Re planning application 2021/94552 Barnsley Road

Re planning 2021-9442 landscape & water management

Extent of flooding from surface water

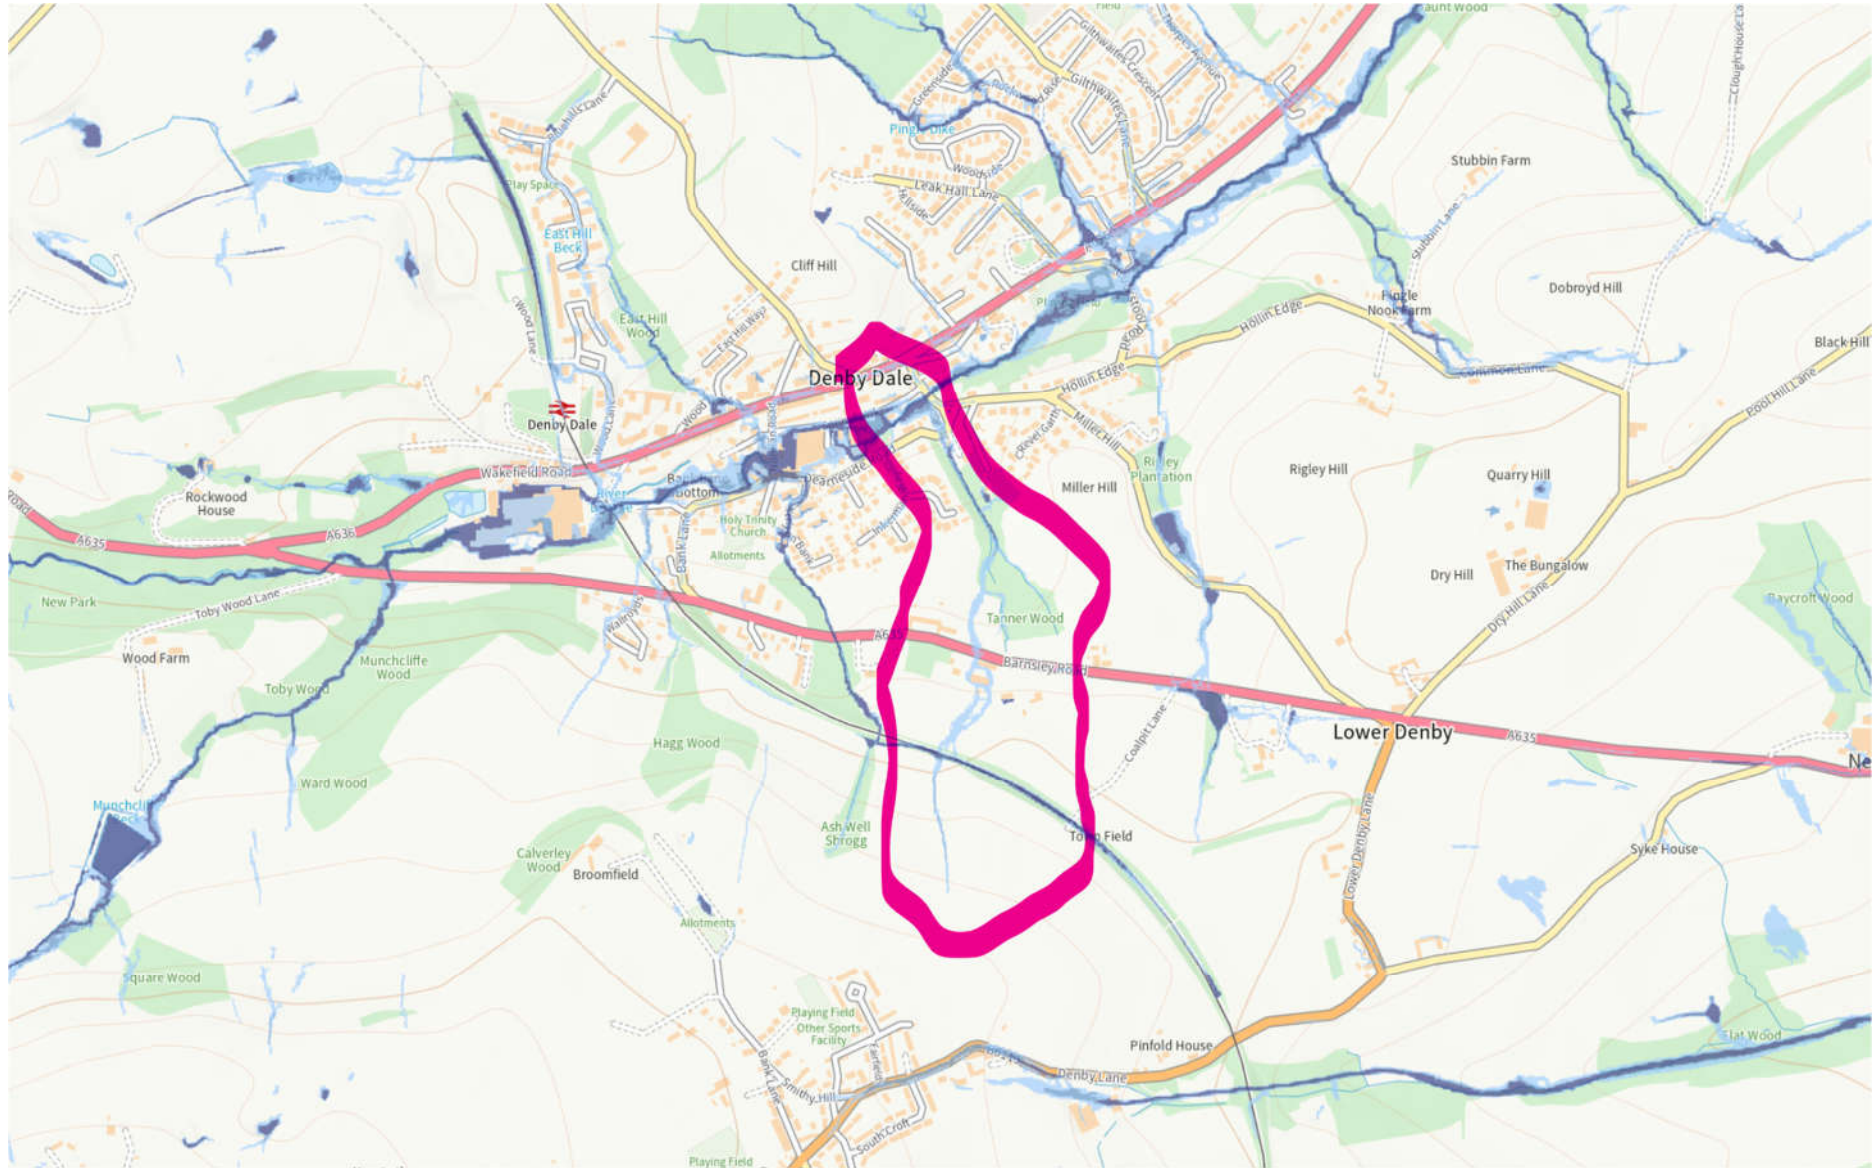
Interface to Tanner Wood, see separate concerns re-the tree impact, But BLOCKING existing ancient route of surface flood water which are coupled with the SINK holes in the development; there is no specific treatment of this matter,

it is requested that the interface here, is carried out as a holistic matter rather than one single element at a time

Photo 2022- March -05

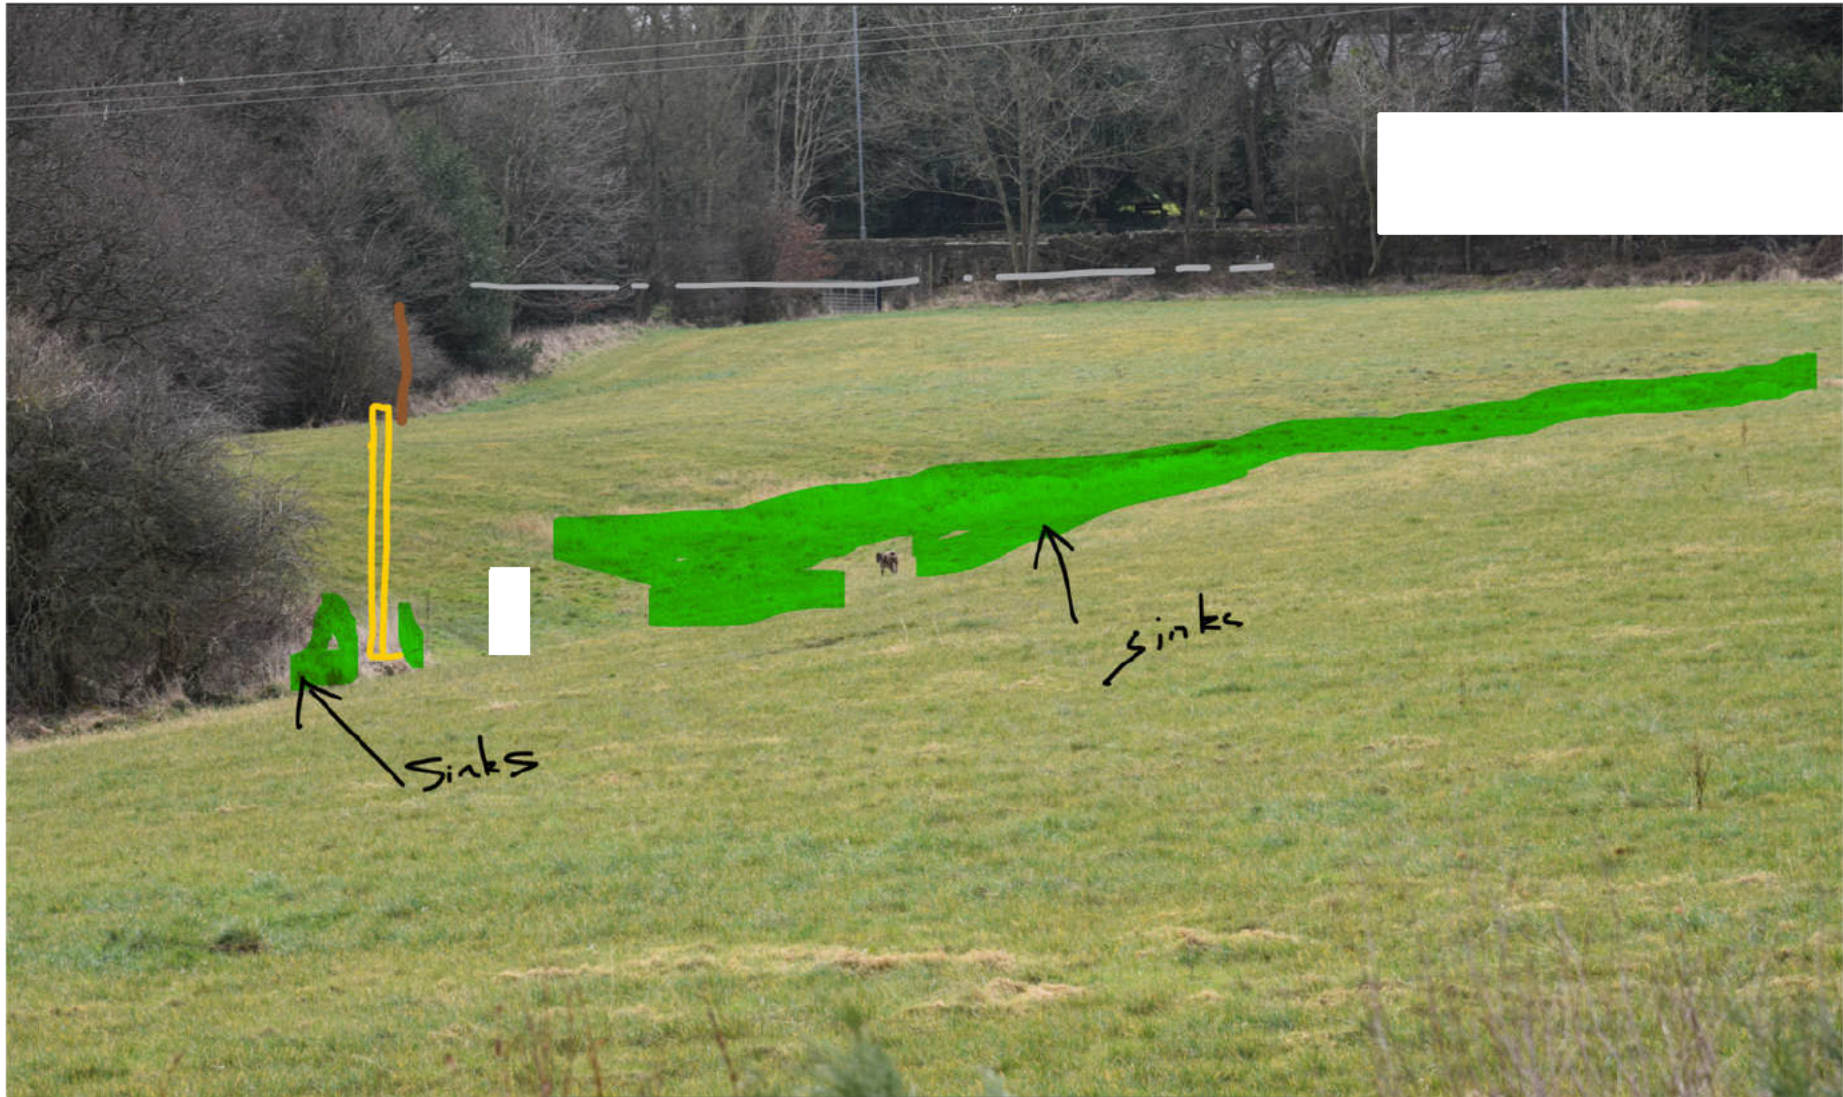
There is no details submitted for the materials of the RW and there is no details of how the land water is managed by drains e.g. French drains

Developers drawing showing Retaining wall 5.5 meter height and the foundation depth/ impact on trees and the water management are NOT interfaced on the developers water management plan

Below is indicated the approx. in grey is the highway level which plots are built up to ; the height of the retaining wall approximated against a dog walker shows the severe height of this made up ground. Even more reason to use material from the North Elevation and lower the plots there

Indicated in red is the area concerned that are referred to as sinks
